### FORD AXODE 1991-2002 OIL PUMP AND VALVE BODY CHECKBALL LOCATION CHANGES

This bulletin provides you with the checkball locations and changes for all AXODE (AX4S) model transaxles from 1991 through 2002, for both the oil pump and the valve body, as everything changed again in model year 1999.

Figure 1
AUTOMATIC TRANSMISSION SERVICE GROUP

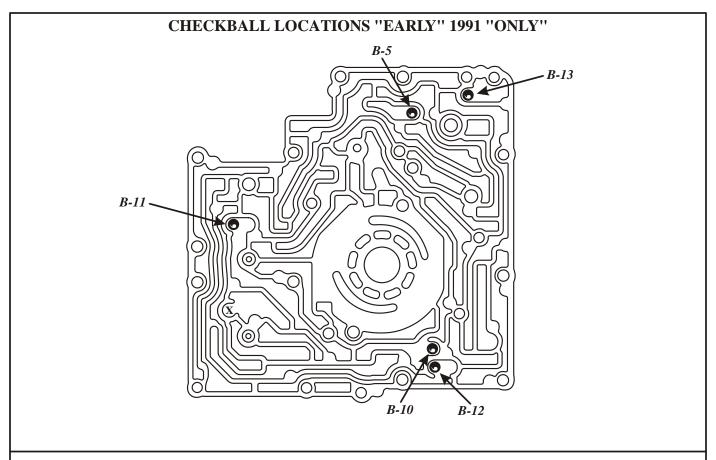
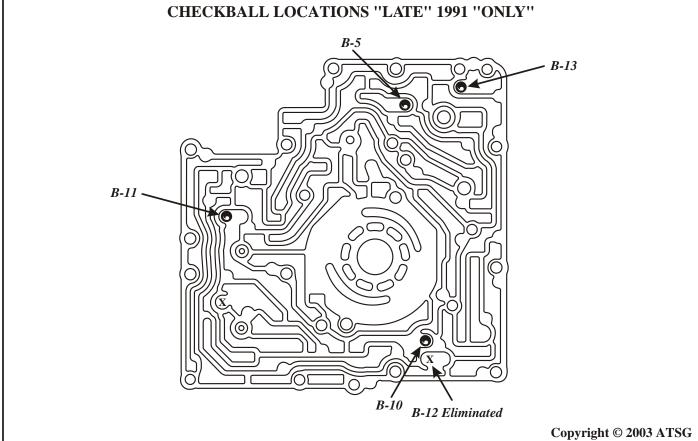
"Early" 1991 Only - Uses 5 checkballs in the locations shown in Figure 1. Use chart above to determine Early or Late transaxle by serial number.

"Late" 1991 Only - Uses 4 checkballs in the locations shown in Figure 1. Use chart above to determine Early or Late transaxle by serial number.

Figure 2
AUTOMATIC TRANSMISSION SERVICE GROUP

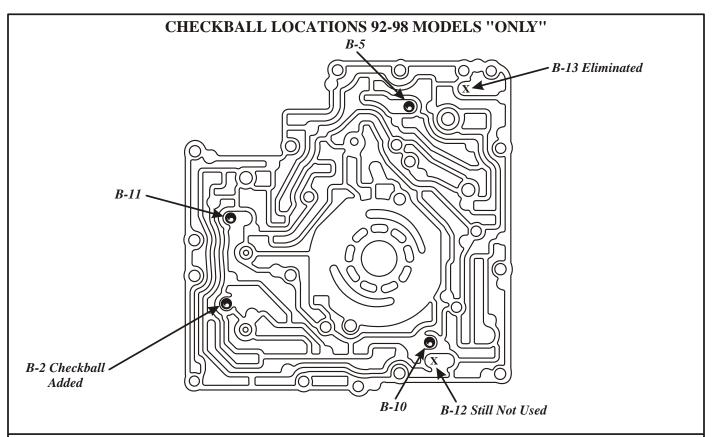
1992-1998 Only - Uses 4 checkballs but in different locations, as shown in Figure 2. B-13 checkball was eliminated and B-2 checkball was added.

1999-2002 Only - Uses 3 checkballs in the locations shown in Figure 2. B-5 checkball was eliminated.
